SUBJECT: DF61 Dirty Mark on Back-side of Original

DATE: July 31, '96  
PAGE: 1 of 3

Phoenix-series  
(DF61)

Model: DF61 (Phoenix series)		Date: 15-Aug-97	No: 20
Subject: Bent Original		Prepared by: S.Hizen	
From: QAC 1st Field Information Dept.			
Classification:	<input checked="" type="checkbox"/> Troubleshooting	<input type="checkbox"/> Part information	<input type="checkbox"/> Action required
	<input type="checkbox"/> Mechanical	<input type="checkbox"/> Electrical	<input type="checkbox"/> Service manual revision
	<input type="checkbox"/> Paper path	<input type="checkbox"/> Transmit/receive	<input type="checkbox"/> Retrofit information
	<input type="checkbox"/> Other (      )

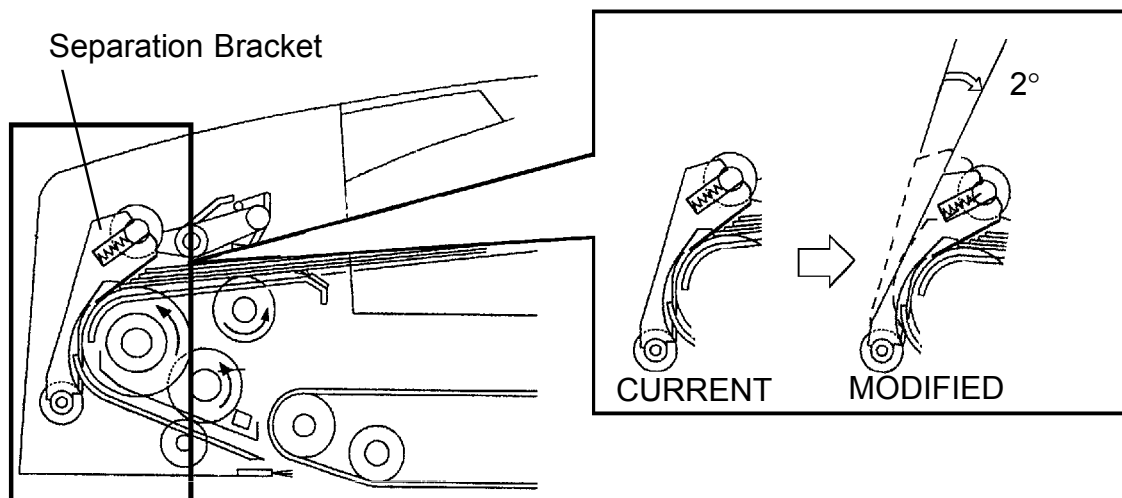
**Problem:** Three dirty marks on the back side of the original.

**Cause:** The toner on the first original is transferred to the back of the second original due to the pressure applied by the pressure lever and the pick-up roller.  
(See the illustration)

The dirty marks created are one of the limitations of the DF61. The degree to which the marks appear varies depending on how completely the image on the first original is fused, the type of image, and the type of paper used.

Due to this countermeasure for the DF61, the specifications listed in the service manual have been changed as follows:

Specification Item	Current DF	Modified DF
Original Weight	52 to 128 g/m <sup>2</sup>	52 to 104 g/m <sup>2</sup>
Original Table Capacity	50 sheets at 80 g/m <sup>2</sup>	35 sheets at 80 g/m <sup>2</sup>

### Separation Bracket

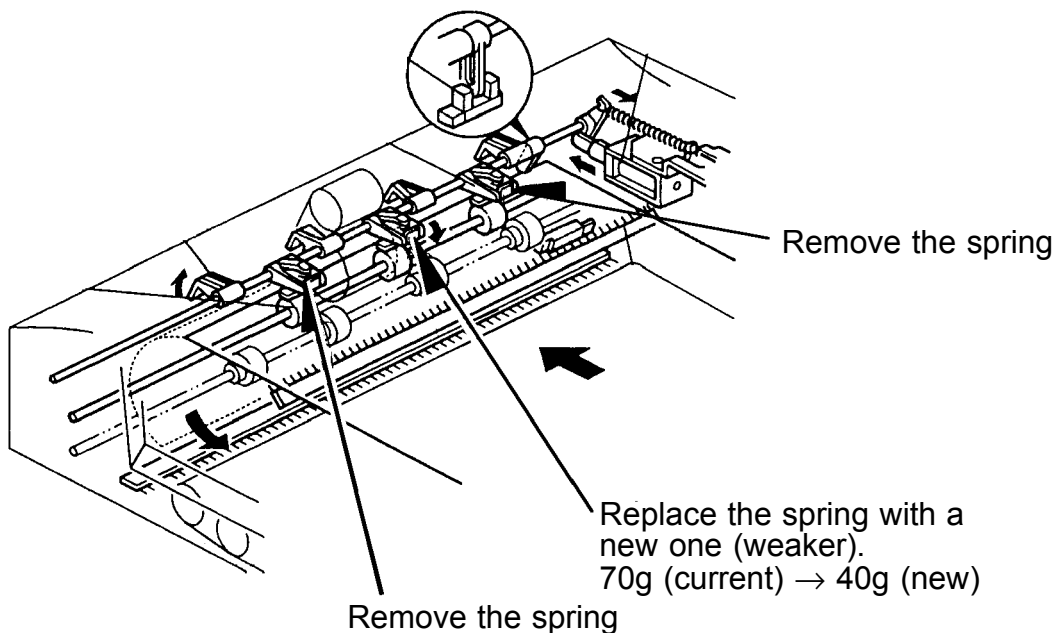
The countermeasure for the dirty marks is designed to reduce the pressure applied to the originals by replacing the entrance guide stopper spring with a new one. This change also results in a decrease in the amount of force used to feed the original and may create an original non-feed problem. Therefore, the separation bracket has been modified to reduce the angle by 2 degrees.

1. Remove the three springs from the entrance guide stopper and install the new spring (P/N:A548 9500) in the middle. If an original non-feed occurs, add the outside springs (P/N:A548 9500) on both sides.

The angle between the separation belt and the originals, and the symptoms caused by the angle.

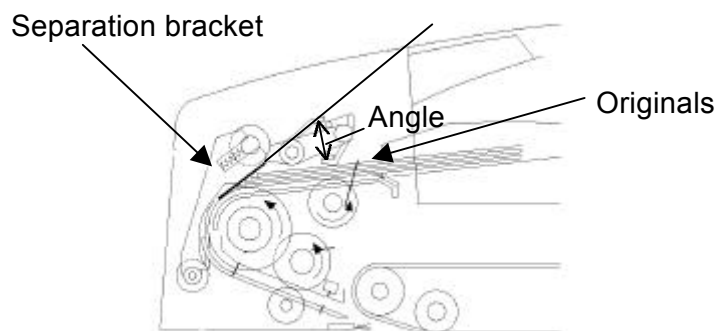
There is a bend (wrapping) on the leading edge of the original the same size as the width of the separation belt. If the bend in the original is large, dirty background may appear on the copy in the area that corresponds with that bend.

The problem occurs as a result of the contact between the edge of the original and the separation belt when the original is fed to the exposure glass. If the upward curl of the original is large or the cut in the leading edge of the paper is not smooth, this problem is more likely to occur.

Large: Good for separation, marginal for original leading edge bending

Small: Good for original leading edge bending, marginal for double-sheet feeds.

Separation bracket

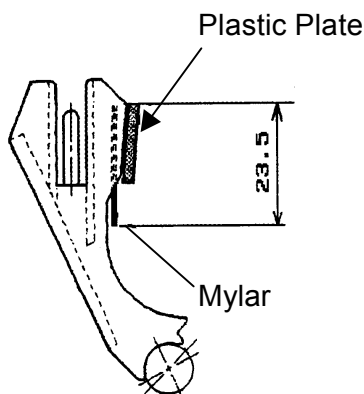
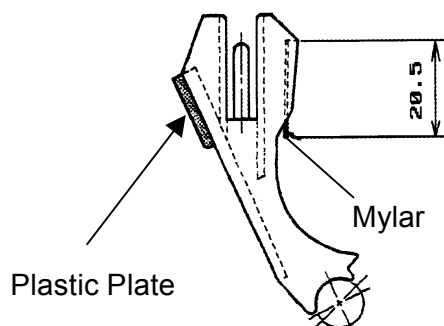
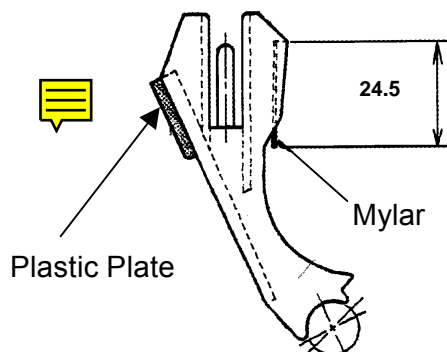
The chart below clarifies the modifications made to the separation bracket.

A548-1291

Bracket Spring: AA06-3503

Bracket for the dirty mark on the back side of original.

A548-9502

Bracket for the leading edge bend.

A548-9504

(This number is for the Bracket and the Spring)
